RE: DeWitt Class I Landfill

AFIN: 01-00117 NPDES Permit No.: ARG160037

| 3 | EPA | | | | | | | | | | | | | | | | | 0 | Form MB No | |)3 |
|--|--|---------|----------|----------------|------------------|-------------------------------------|---------------------------------|--|---------|--|-----------------------------------|-------|-------------------|-----------------------------|--------------|-------|--------------------------------------|---------|---------------|------|----|
| | NPDES Compliance Inspection Report | | | | | | | | | | | | | | | | | | | | |

RE: EMS Class 1 Landfill, AFIN 01-00117 Permit No. ARG160037

| Water Division NPDES Photographic Evidence Sheet | | | | | | | | |
|---|---|--|-------|----------|-------|---------|-------|------------|
| Photo # | 3 Of 6 | | 6 | | Date: | 4/16/09 | Time: | 10:08 a.m. |

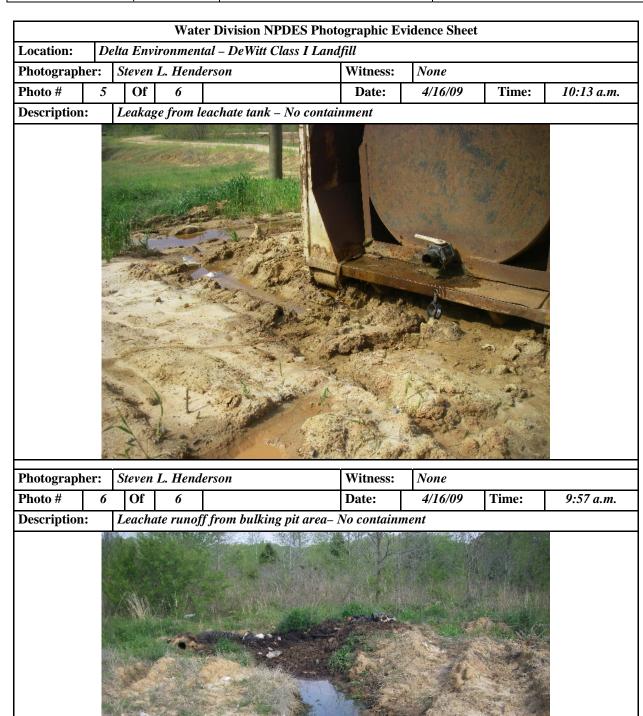
| Water Division NPDES Photographic Evidence Sheet | | | | | | | | |
|---|---|--|-------|----------|-------|---------|-------|------------|
| Description: Evidence of leachate from eroded cell entering sedimentation pond. | | | | | | | | |

Description: Evidence of leachate and waste in storm water drainage to sedimentation pond.

ADEQ Comment 2. Evidence of leachate entering the storm water drainage system and sedimentation pond

EMS Response – The leachate leak from the storage tank and all leachate breakouts in the interim cover system have been repaired. The recent rainfall events have made the repair of the landfill cover system difficult at best. EMS is aggressively performing repairs of the landfill interim cover as weather and field conditions permit.
